MEADOWBROOK

AN ADDITION TO SEDGWICK COUNTY, KANSAS

RE: SUB 2003-115 -- One-Step Final Plat of Meadowbrook Addition

RE: SUB 2003-115 -- One-Step Final Plat of Meadowbrook Addition

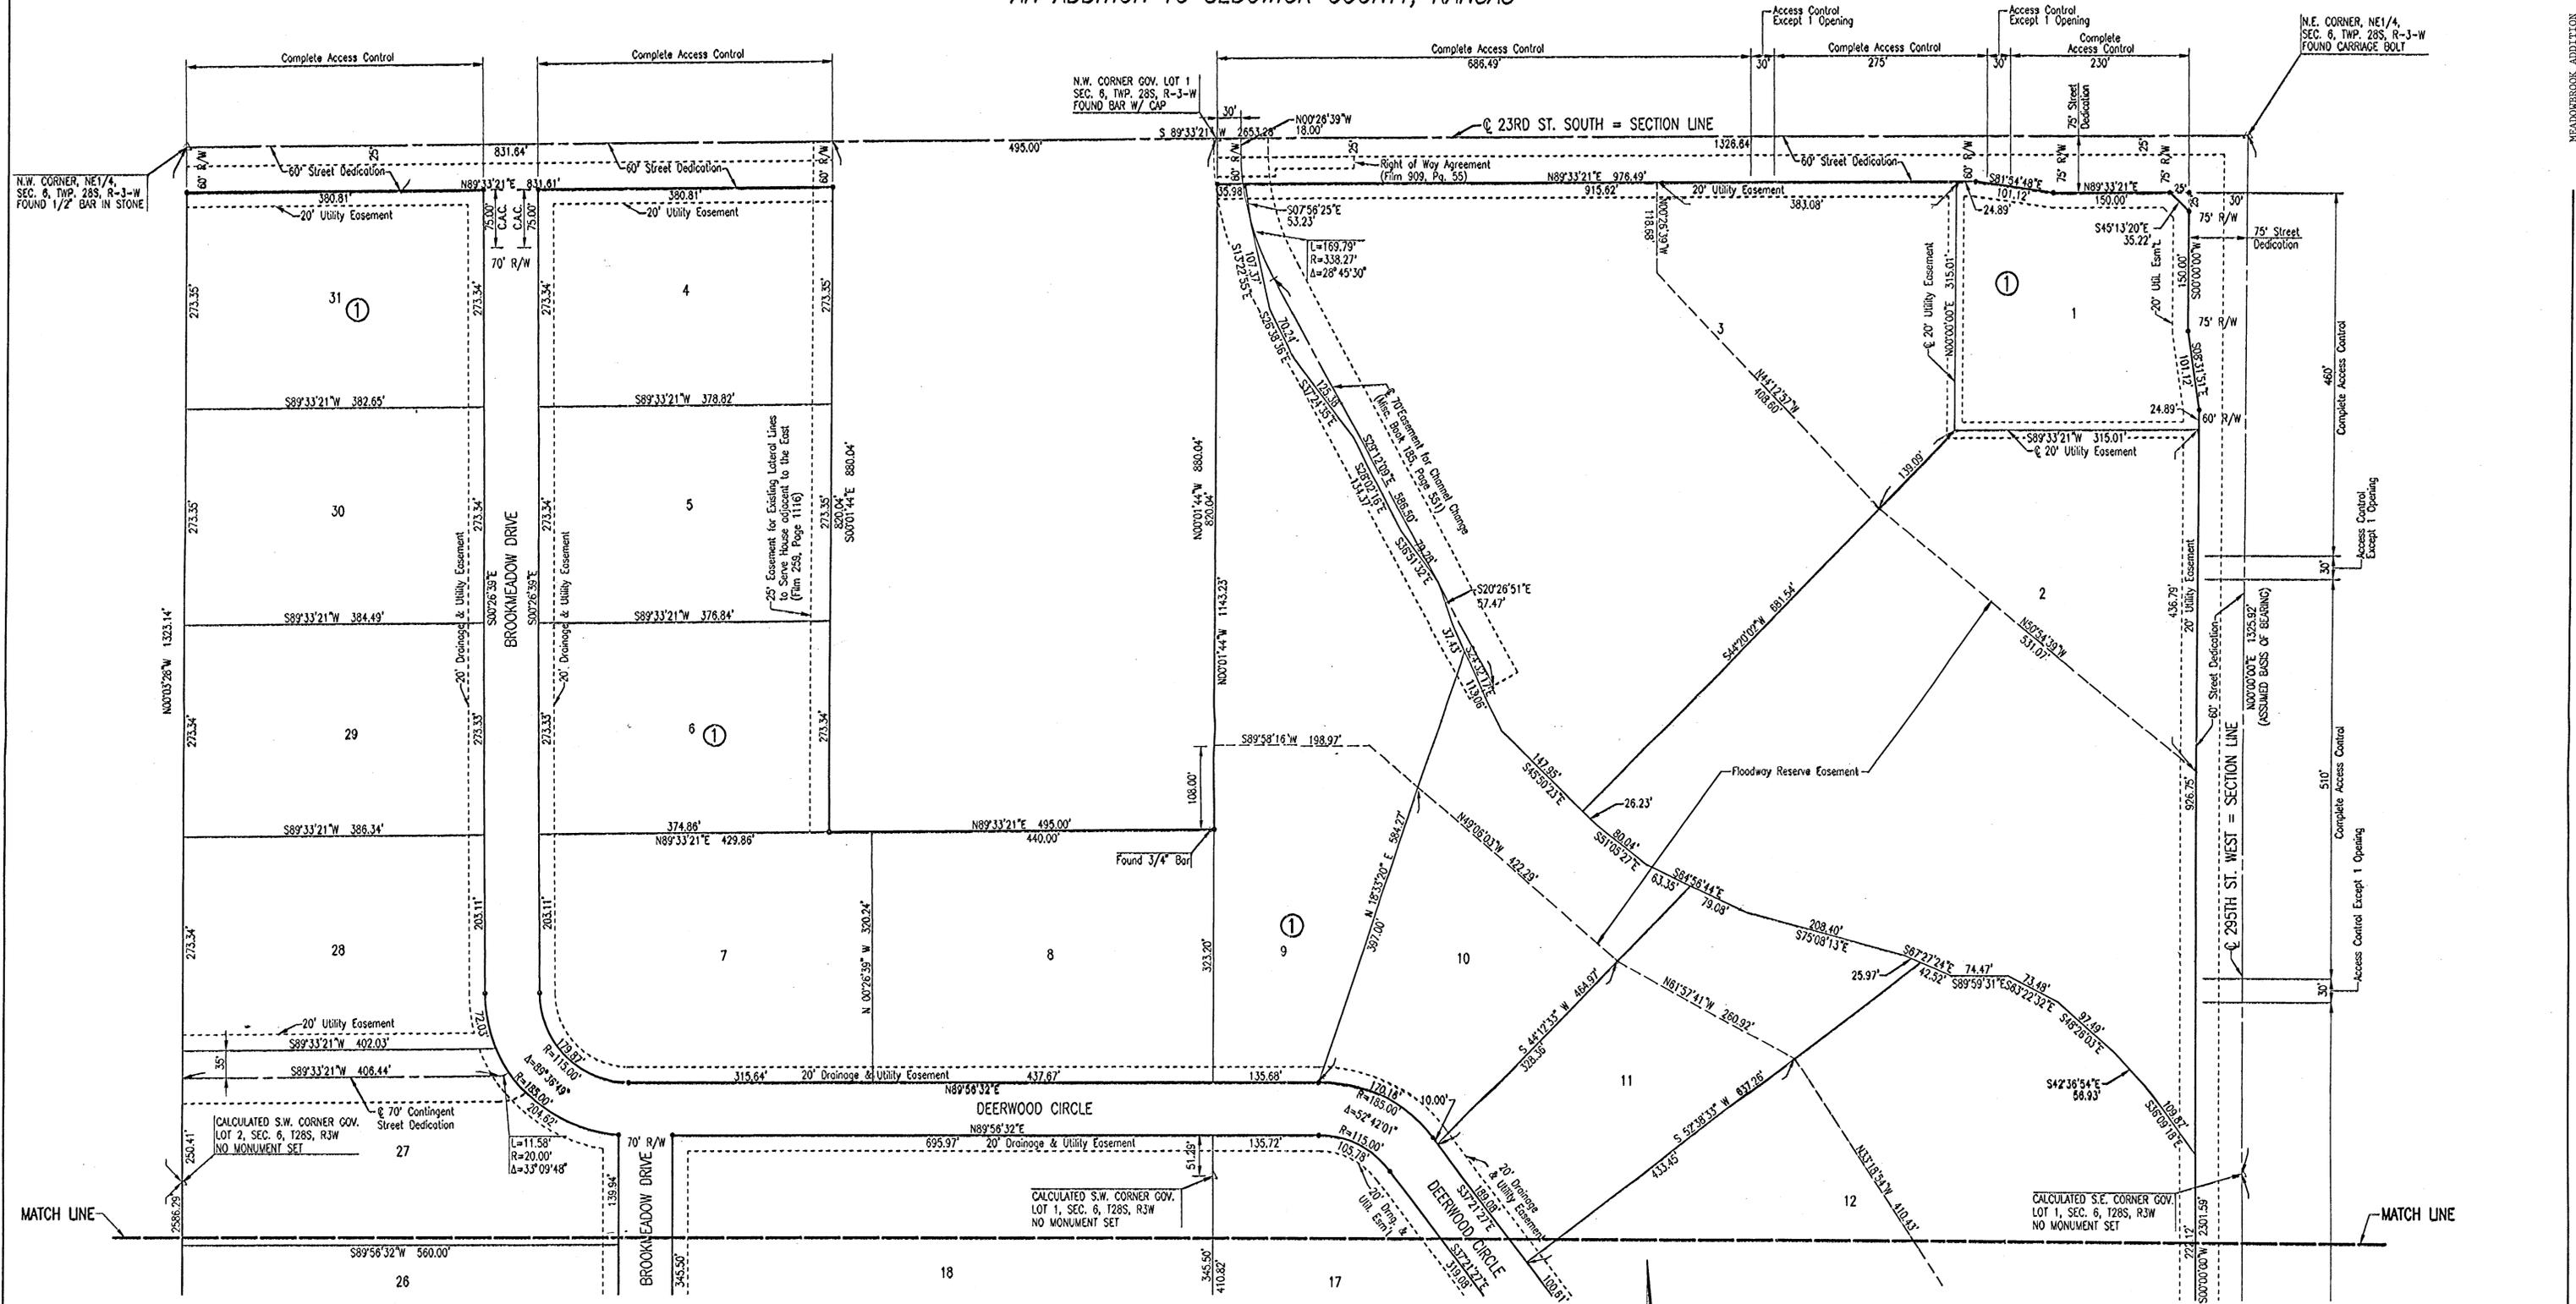
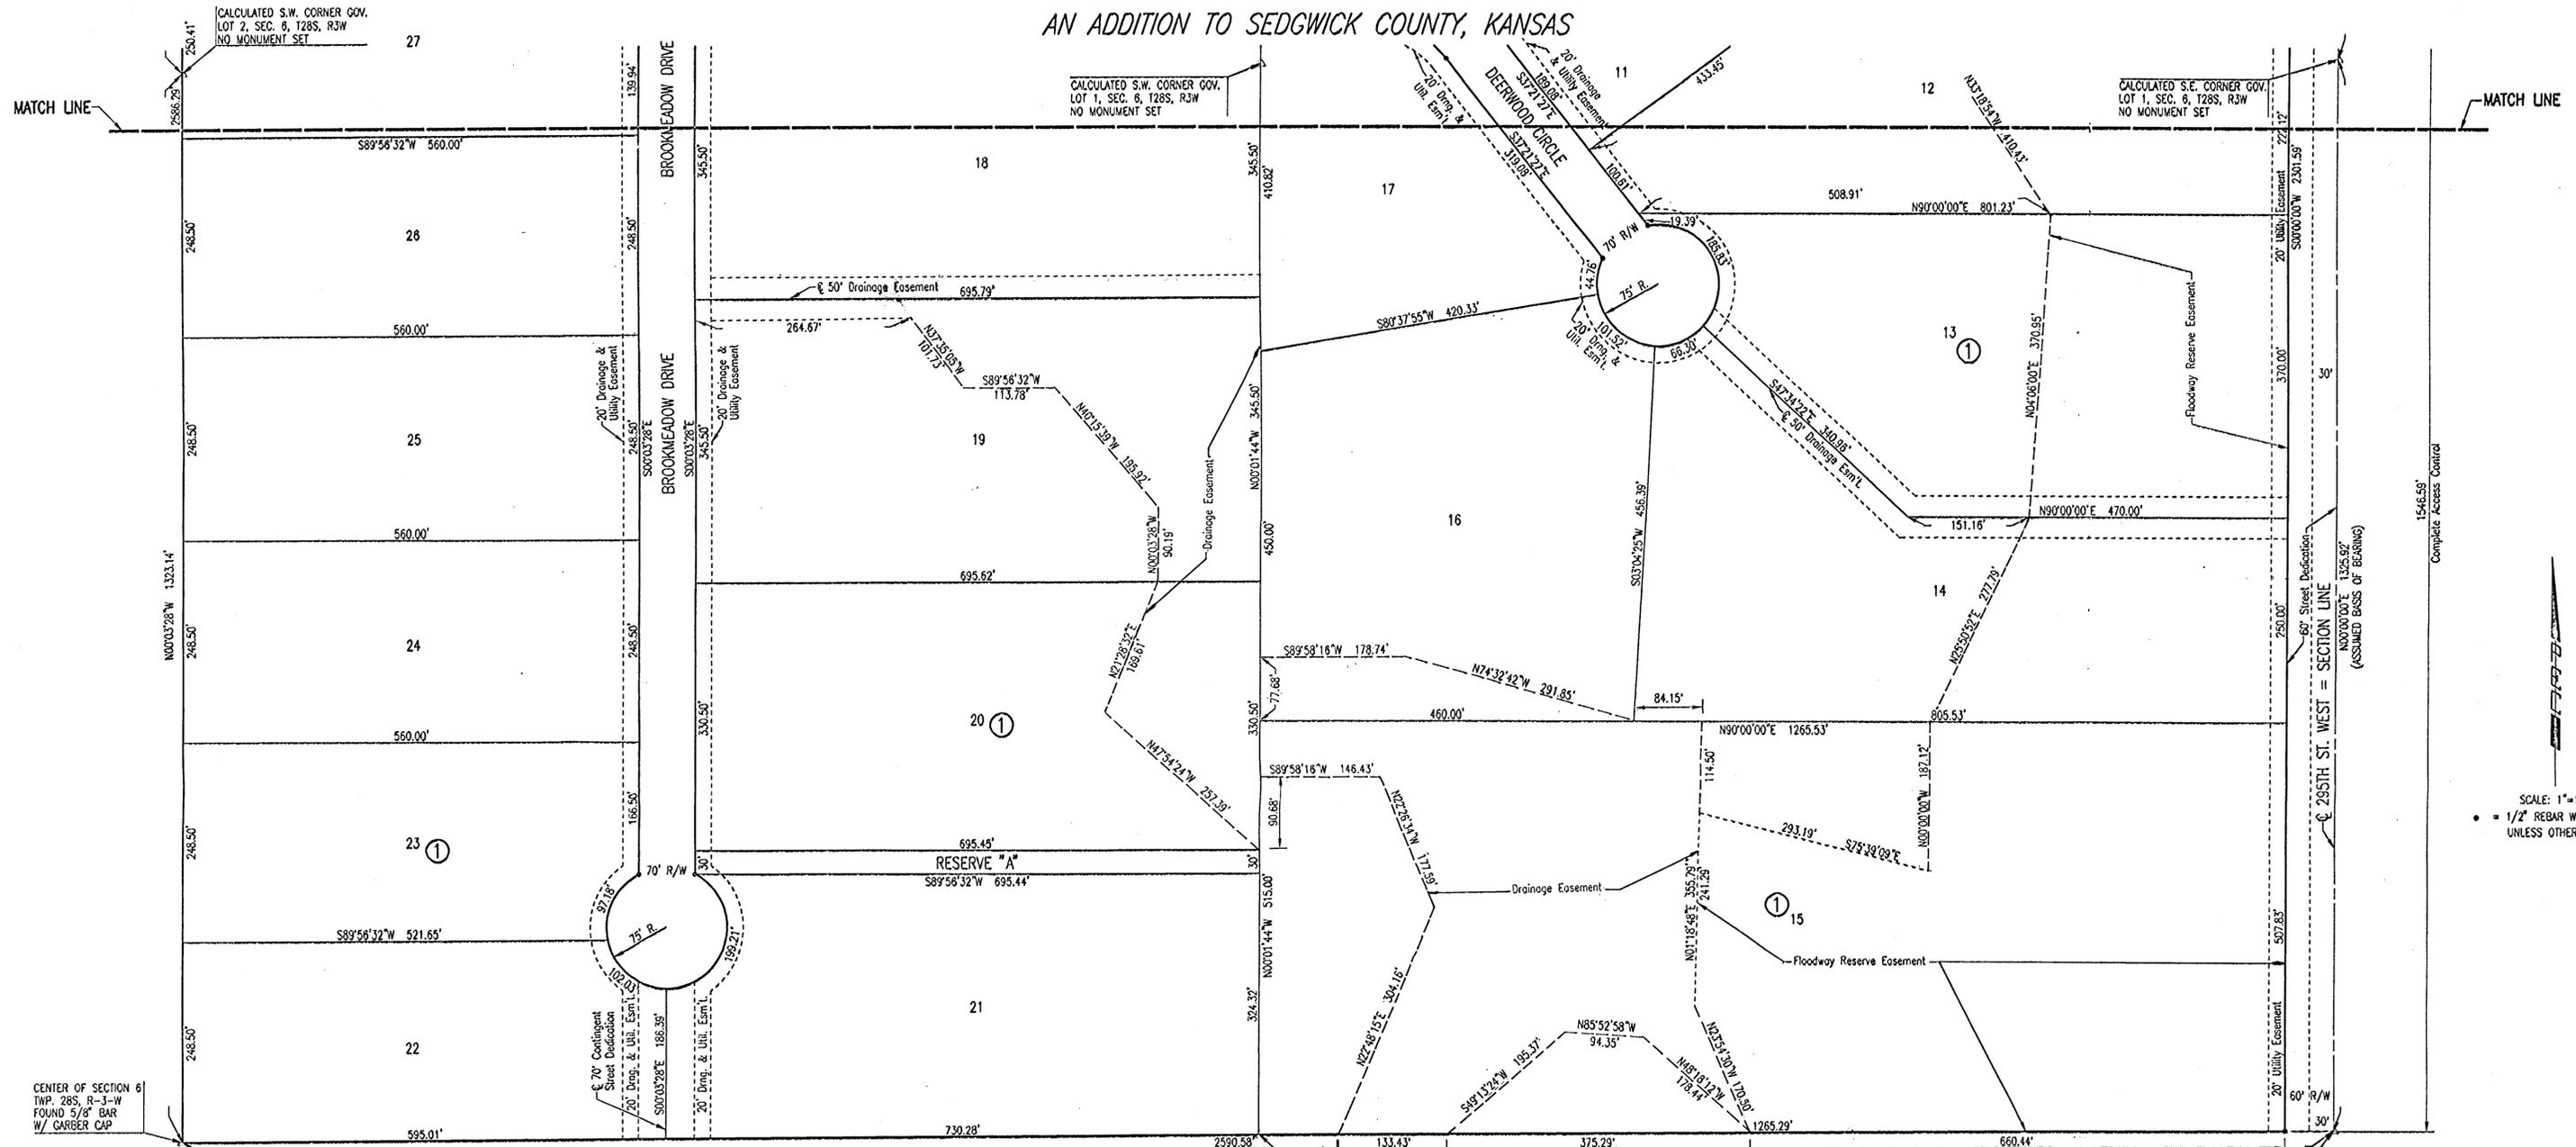
- A. Since neither sanitary sewer nor municipal water is available to serve this property, the applicant shall contact **County Code Enforcement** to find out what tests may be necessary and what standards are to be met for approval of on-site sewerage and water wells.

- C. **County Engineering** needs to comment on the status of the applicant's drainage plan. *A flood study is needed with encroachment routine and hydrology. DWR permits are needed. The Applicant will need to submit letter to FEMA for map revision to reflect the change in flood plain. The drainage plan needs to address offsite drainage coming in from the west and from the south, as well as terraces. Additional drainage easements or floodway reserve may be required. Minimum pads are needed based on flood study and drainage plan.*

- D. The floodplain should be covered by a floodway reserve agreement. The plat's text shall denote the creation of the floodway reserves in addition to including the standard floodway language.

- E. **County Engineering** needs to comment on the access controls. The plat denotes six openings along 23rd St. South and five openings along 295th St. West. *Complete access control is required along 23rd St. South for Lot 5, Block 1 and Lot 32, Block 1. Additional access controls need to be determined upon discussion with County Engineering prior to MAPC meeting.*

- F. In accordance with Access Management Regulations, complete access control is required for arterials intersecting with collectors/local streets. Complete access control of 75 feet is needed along Brook Meadow Drive from 23rd St. South.

- G. A corner clip is needed at the intersection.
- H. Per Sedgwick County Fire Department, access drives to any structure in excess of 150 feet from the edge of the roadway will need to be installed prior to final framing inspection, preferably before the start of any above grade construction work. Such drive to be installed according to fire department specifications: (1) Twenty feet of drivable surface is provided the entire length of the access drive designed to withstand the weight of fire apparatus in inclement weather with provisions for turning fire apparatus around. (2) To meet fire department specifications, the surface will need to be an all-weather material consisting of rock or gravel, ground asphalt, laid asphalt or concrete. It is to be applied a minimum of 4 inches in depth consistently over the entire width and length of the driving surface (gravel is prone to problems during extended periods of rain or snow and should be used with caution unless a good solid compacted base has been installed).

- I. A covenant shall be submitted regarding Reserve A platted for private drive purposes, which sets forth ownership and maintenance of the private drive, and future reversionary rights of the reserve to the lots benefiting from the reserve.

- J. The applicant shall guarantee the installation of the proposed streets. Cul-de-sacs will require 36' wide rock streets.
- K. The Applicant has platted a contingent dedication of street right-of-way extending to the west and south property line. On the final plat tracing, the contingent dedications of right-of-way need to be referenced in the plat's text. The language should state that "the contingent street dedications are hereby contingently dedicated as street right-of-way to become effective upon the platting of any adjacent subdivision having a street connecting thereto. The costs of constructing said street, are to be borne by the person(s) or agency that owns said adjacent subdivision."

- M. County Fire Department needs to comment on the street length of Deer Wood Circle (1,400 feet). The Subdivision Regulations limit rural cul-de-sacs to 1,200 feet in length unless a stub street connection or contingent street dedication is provided for future access to adjoining tracts. The street length is approved.

- N. The signature line for the County Commissioners Chairman needs to reference "Tim R. Norton".
- O. GIS needs to comment on the plat's street names. GIS has requested that the street names be revised to "Deerwood Cir" and "Brookmeadow Dr".

- P. For lots fronting on cul-de-sacs, the lot frontage is required to be 50% of the required lot width (200 feet). Lot 15, Block 1 does not meet this 100-ft frontage requirement. A modification needs to be approved by MAPC.

- Q. The Subdivision Committee requested the platting of internal utility easements to serve future sewer and water extensions.
- R. The platlor's text shall include language that a drainage plan has been developed for the plat and that all drainage easements, rights-of-way, or reserves shall remain at established grades or as modified with the approval of the applicable City or County Engineer, and unobstructed to allow for the conveyance of stormwater.

At the regular meeting of the Metropolitan Area Planning Commission on October 23, 2003, the above captioned plat was considered. The action of the Planning Commission was to approve the plat as recommended by the Subdivision Committee, subject to the conditions stated in our letter dated October 17, 2003, with the addition of the following to Item E: County Engineering has approved the proposed access Controls.
